**JOINT REGIONAL PLANNING PANEL
(Sydney East Region)**

JRPP No	2016/SYE031
DA Number	LDA 2015/0654
Local Government Area	City of Ryde
Proposed Development	Demolition of existing buildings, amalgamation of the lots and construction of a mixed use development containing a total of 105 residential units & 269m ² of commercial floor space.
Street Address	723-731 Victoria Road, 10 Little Church Street and 3-7 St. Anne's Street Ryde
Applicant	CDArchitects
Number of Submissions	To the original proposal: 13 submissions received To the amended proposal: 3 submissions received
Regional Development Criteria (Schedule 4A of the Act)	General Development over \$20 Million Cost of Works:\$34,144,723
List of All Relevant s79C(1)(a) Matters	• Environmental Planning and Assessment Regulation 2000; • Environmental Planning and Assessment Act 1979; • State Environmental Planning Policy (State and Regional Development) 2011; • State Environmental Planning Policy (Infrastructure) 2007; • State Environmental Planning Policy No. 55 – Remediation of Land; • State Environmental Planning Policy (Building Sustainability Index: BASIX); • State Environmental Planning Policy No 65 – Design Quality of Residentia

Figure 18 – separation between adjoining site at 721 Victoria Road. One window facing 721 Victoria Road which is off a study area and has opaque glass.

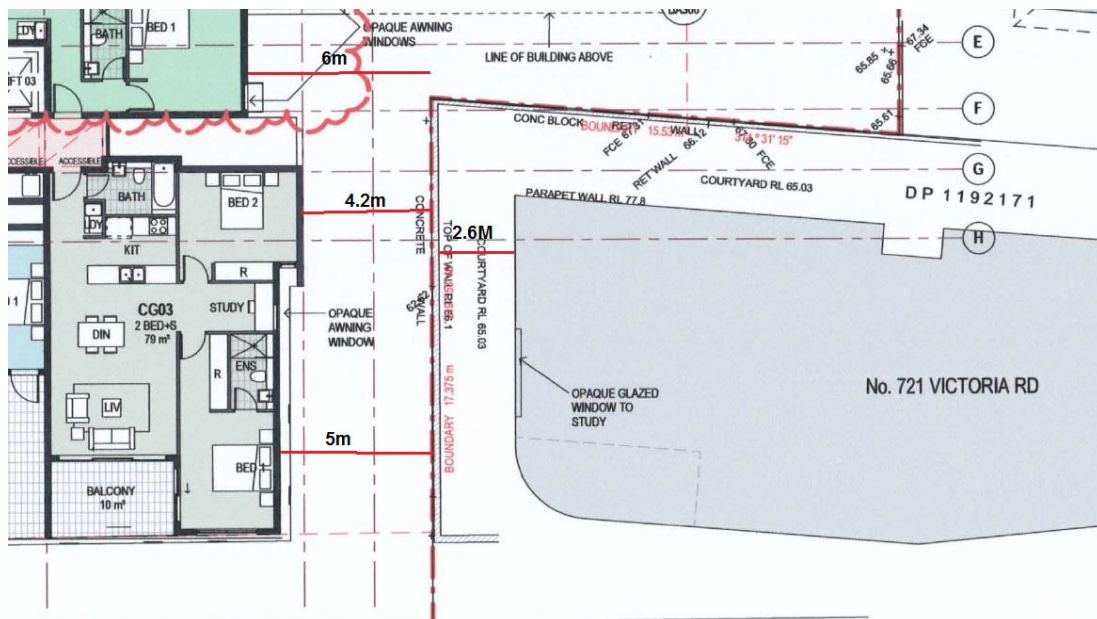
The proposal does not comply with the minimum separation distance of 6m (Ground – Level 3) or 9m (Levels 4 and 5) to the eastern and southern side boundary shared with No. 721 Victoria Road, see **Figure 18** below. Despite the numerical non-compliance, the reduced setback is acceptable as there are a limited number of windows on the elevation, any proposed windows relate to low activity areas of the unit such as studies or bedrooms and the windows are treated with opaque glass or privacy screening to orient the view to Victoria Road. In addition, the western elevation of the building at No. 721 Victoria Road does not have living room windows or private open space areas oriented to the side of the proposed development. The variation in the building separation was also supported by the UDRP. The variation to the separation requirement is acceptable in this case.

Figure 19: Typical layout of apartment C03. Condition 1(a) imposed to provide north facing window to bedroom 2 to improve solar access to the room.

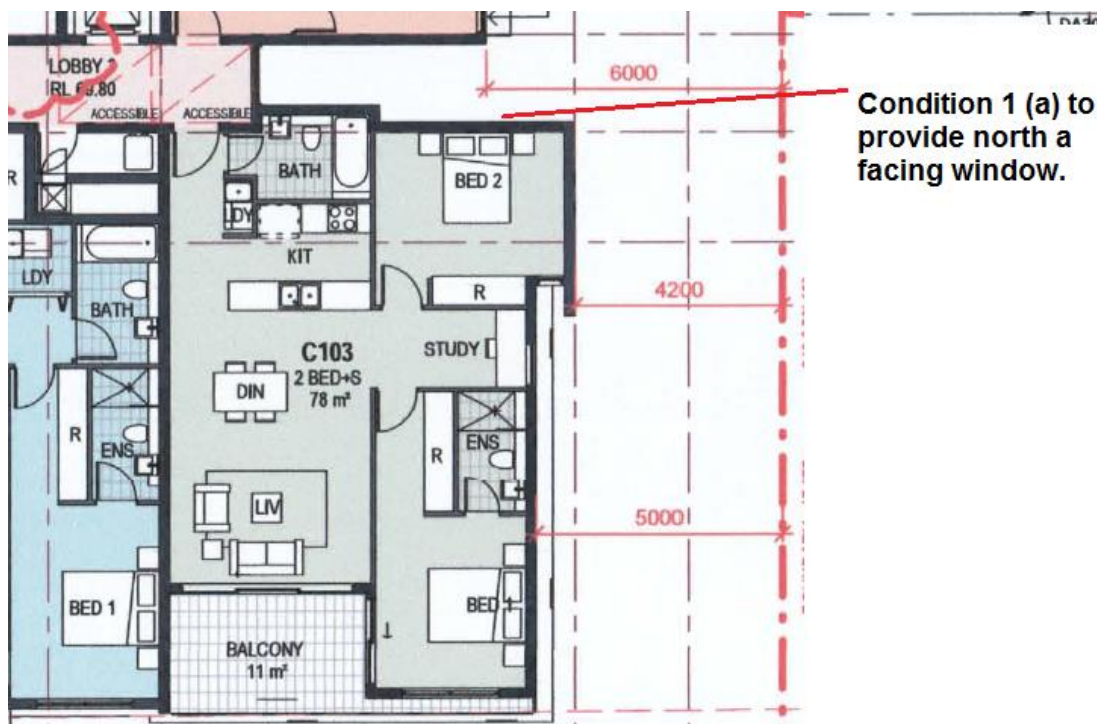
Nevertheless, the proposal satisfies the objectives of optimising the number of apartments receiving sunlight to habitable rooms, primary windows and private open space. 71.4% of the apartments will receive 2 hours of solar access. In addition, to further improve amenity to five units, **Condition 1(a)** has been included to provide a north facing window to Bed 2 of units CG03, C103, C203, C303 and C403. See **Figure 19** below.

Figure 21 – Overshadowing at 9am – some overshadowing to the north west corner of 721 Victoria Road.

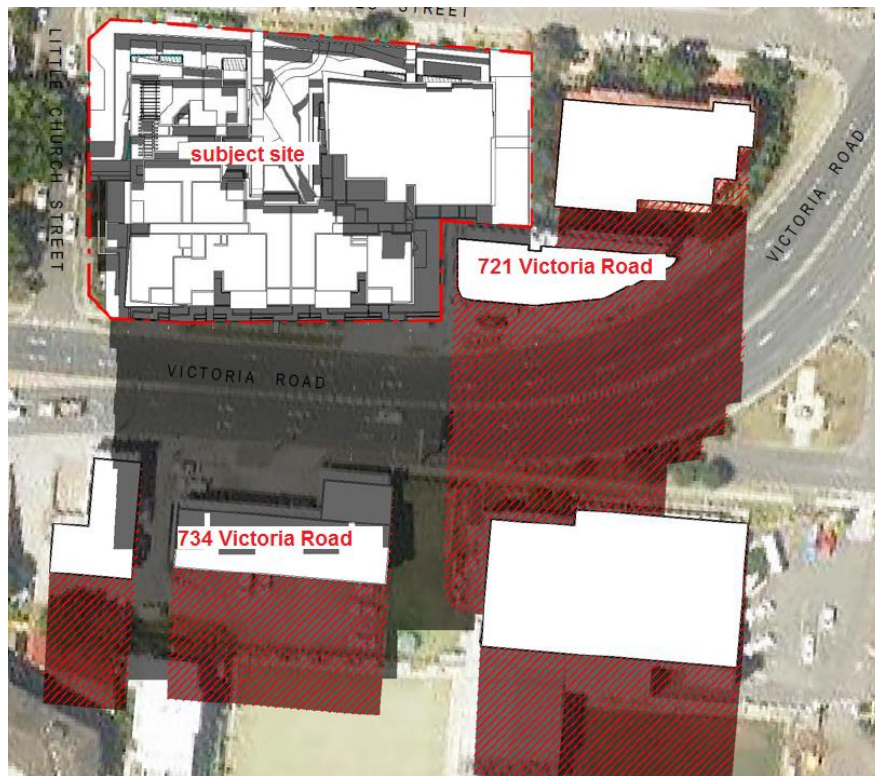
The DCP requires the built form of new development to be designed to minimise shadow impacts on surrounding properties. The submitted diagrams demonstrate that shadow casted by the proposed development will impact the north facing corner units on the adjoining property at No. 721 Victoria Road. The remaining shadows will be cast over Victoria Road which is located to the south of the site. Given the orientation of the site any redevelopment at St Annes Street will overshadow the adjoining southern site, in this case, 721 Victoria Road. It should also be noted that 721 Victoria Road is a remnant site with reduced setbacks. The proposed development predominantly complies with the required setback and complies with the

height where the site adjoins 721 Victoria Road. It is considered the shadow impact of the proposal is acceptable given that the overshadowing is only for a small section of 721 Victoria Road, and the height and setback of the buildings are generally in accordance with council's LEP and DCP controls.
